# Value Engineering Study

**East Side Coastal Resiliency Project**

Preliminary  
Value Engineering Study Report  
for

East Side Coastal Resiliency Project  
New York, NY

Sketch shows Reach H and Half of I

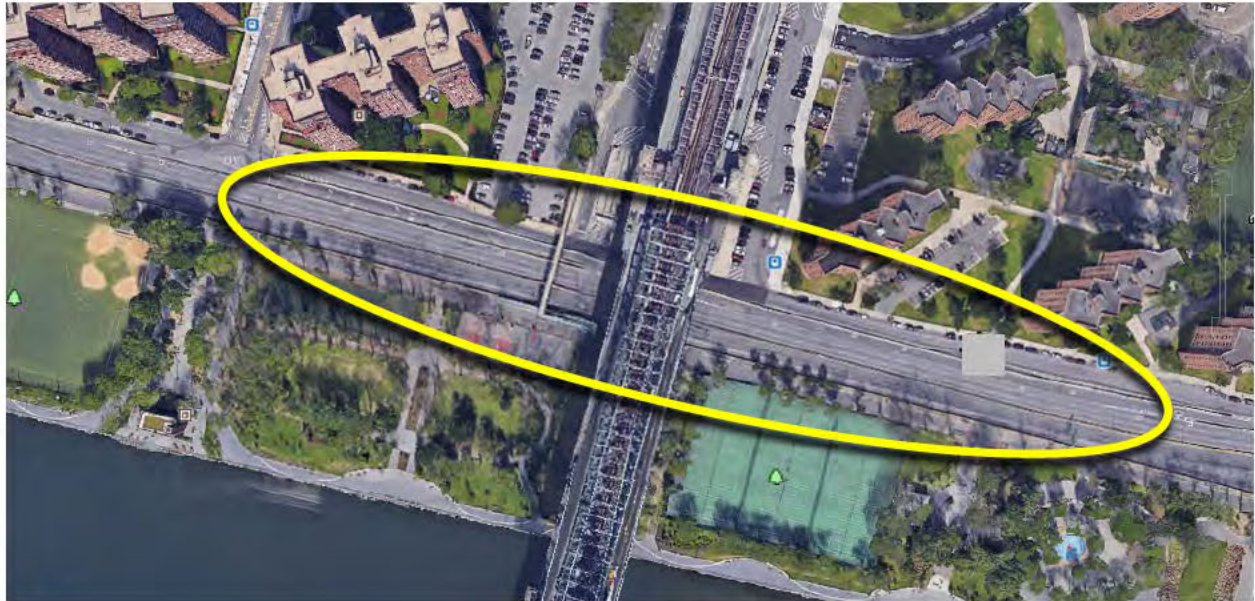
- Area of lane shift transition to service road.
- Make lane adjacent to wall available for construction.

Alternative No.: C-51

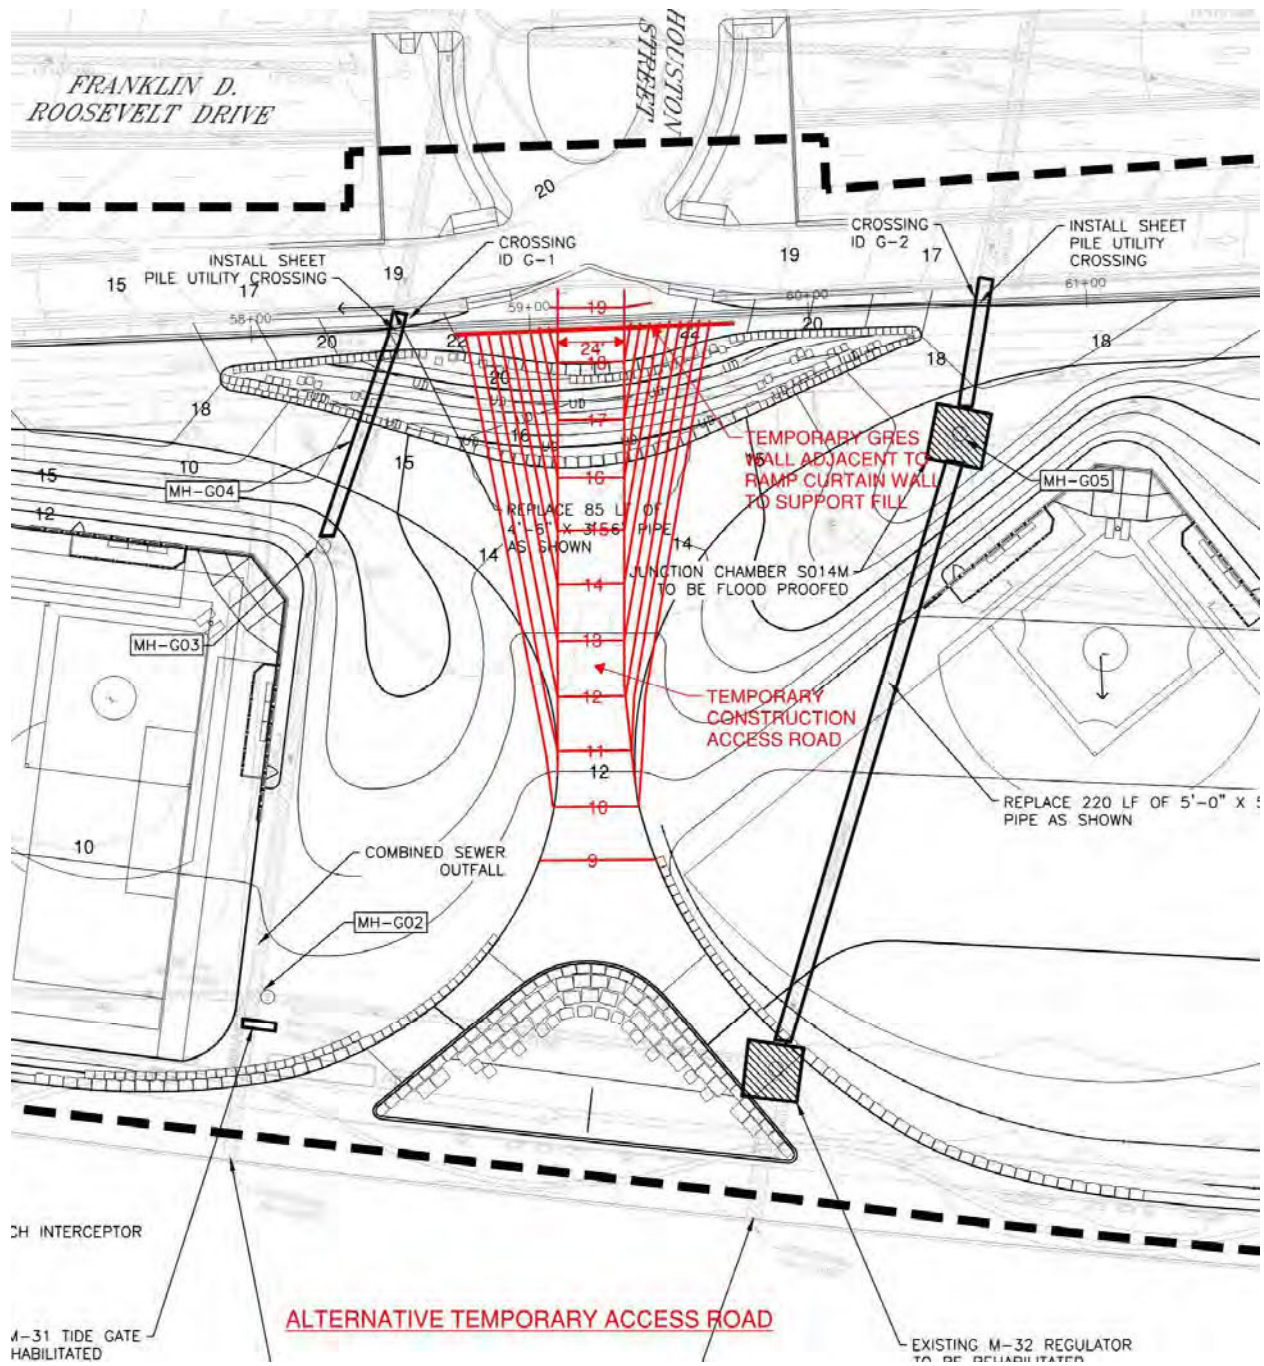
Providing a second access point to the park will likely increase productivity and shorten overall construction duration, as well as improve site safety. Congestion from construction vehicles at the only current entrance at Montgomery Street will be alleviated.

Installation of the temporary access ramp on fill will require the installation of a reinforced earth (GRES type) retaining wall parallel to the Houston Street ramps and overpass curtain wall in order to avoid loading of these facilities. The existing pedestrian ramp from the overpass needs to be supported to accommodate loading from construction vehicles. Temporary fill will not have to be removed, since the area is being built up in final condition.

Alternative No.: IA-03

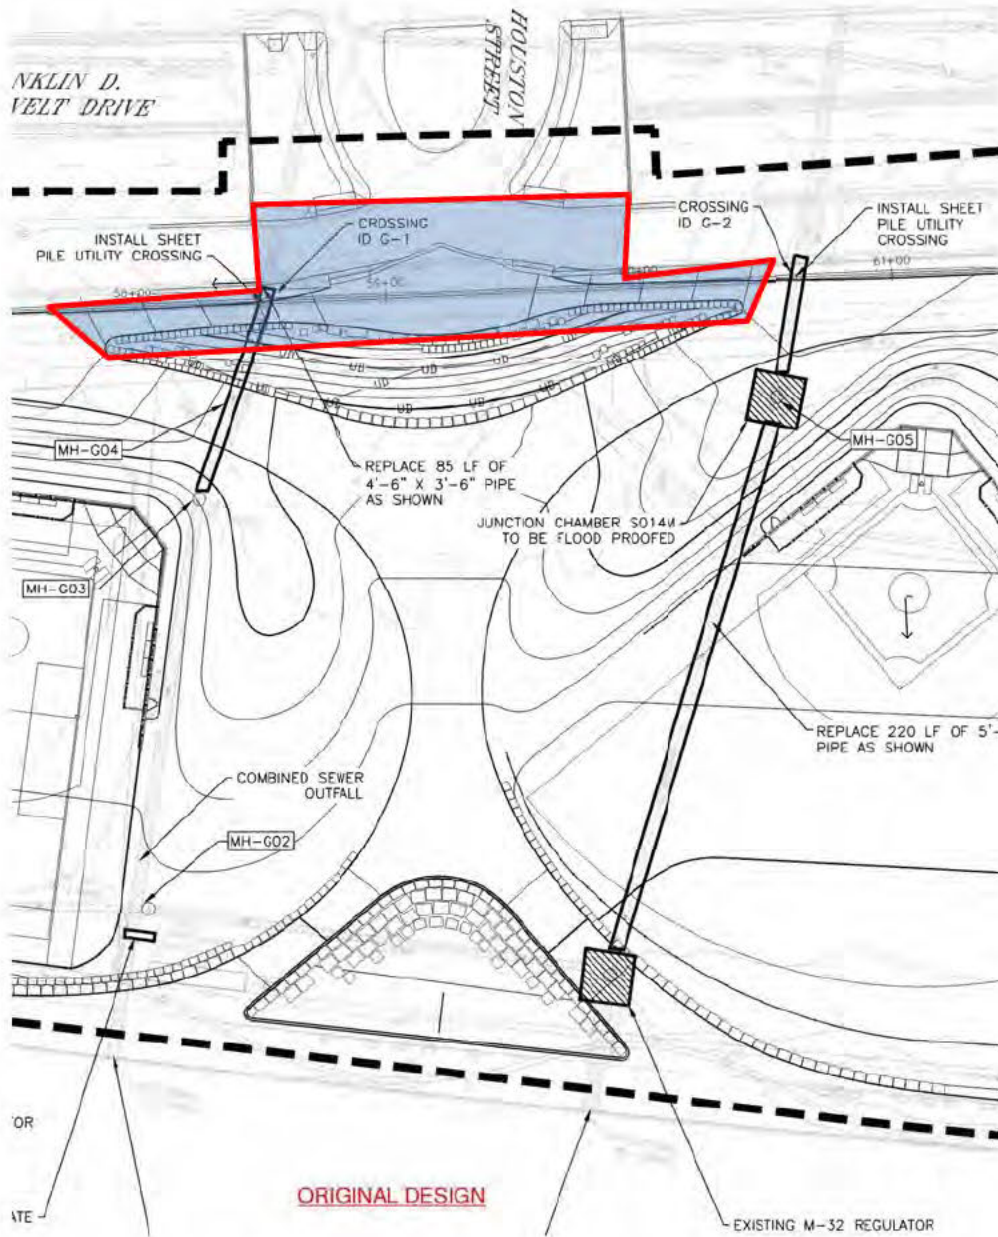
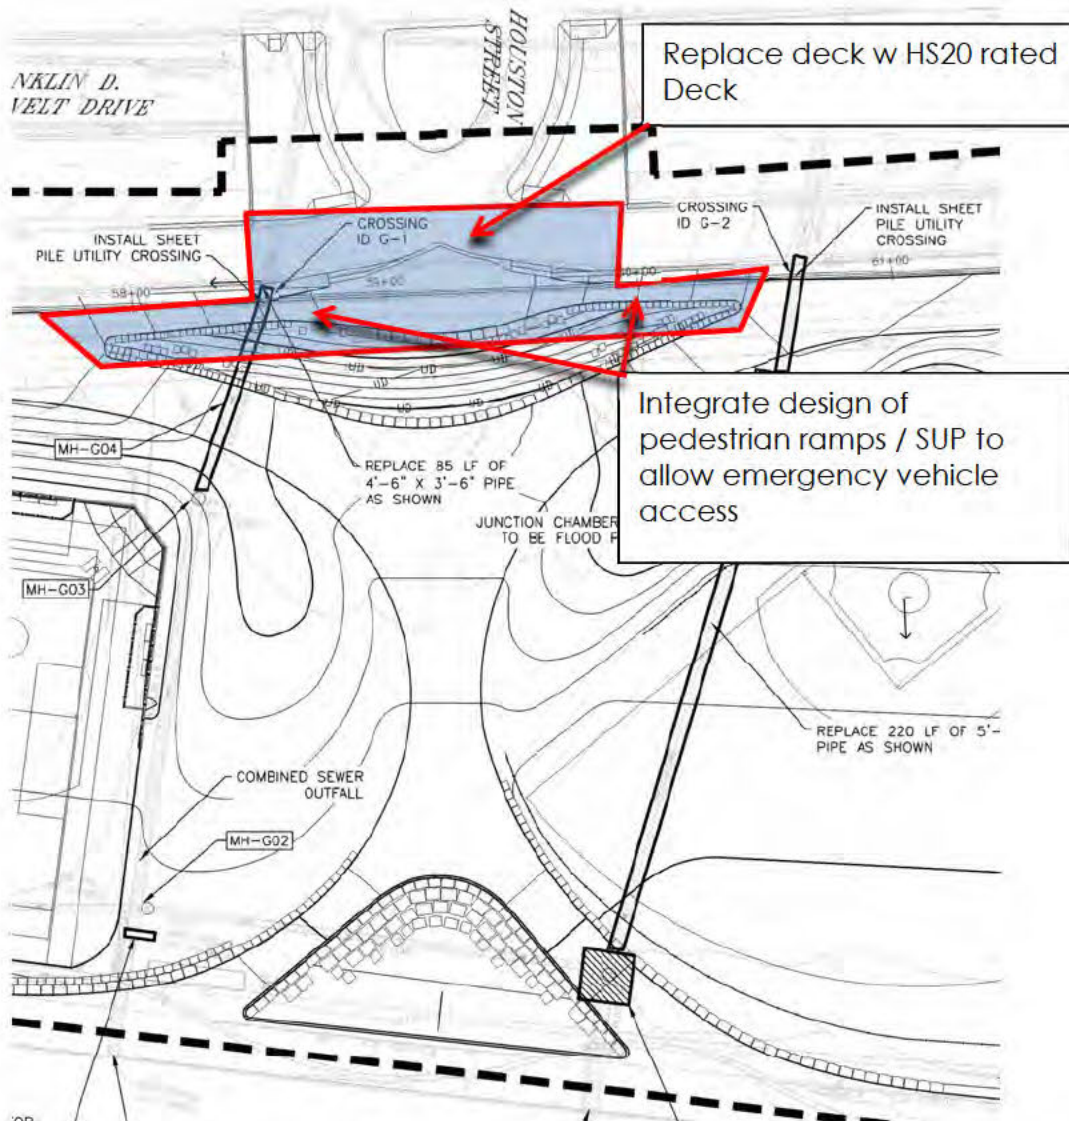
Existing portion of the Houston Street deck is not HS20 rated.
